MILITARY SPECIFICATION

RELAYS, REED, DRY,
GENERAL SPECIFICATION FOR

This amendment forms a part of Military Specification MIL-R-83516A(USAF), dated 3 March 1983, and is approved for use by the Department of the Air Force and is available for use by all Departments and Agencies of the Department of Defense.

FIGURE 1. Typical circuit for operate and release time and contact bounce with typical traces.

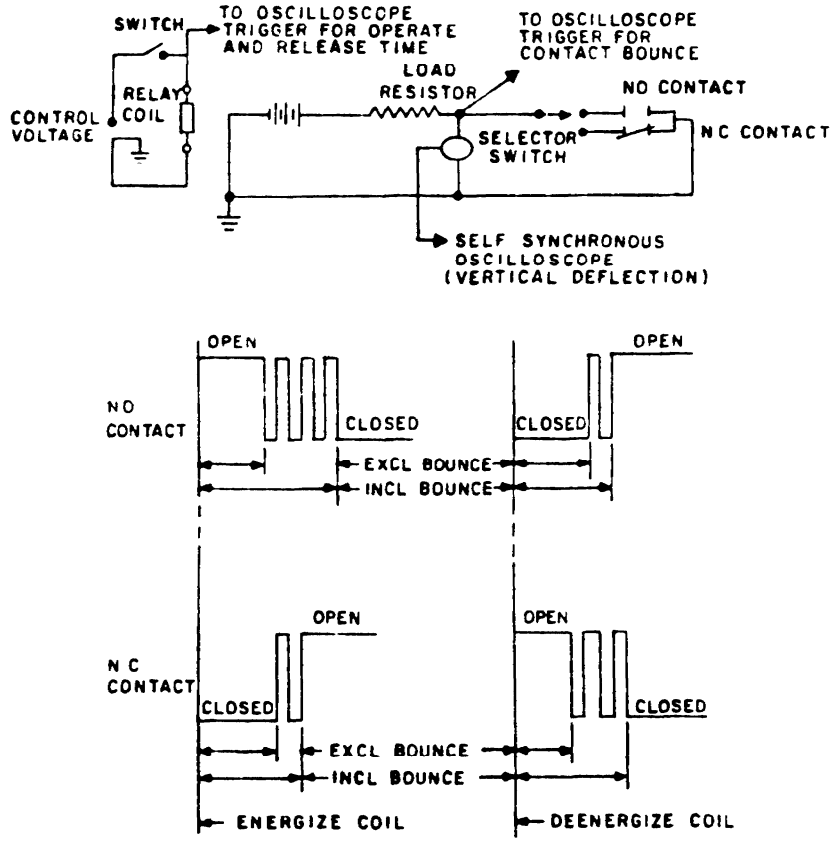
FIGURE 1: Delete and substitute new figure 1 as printed on page 2 of this amendment.
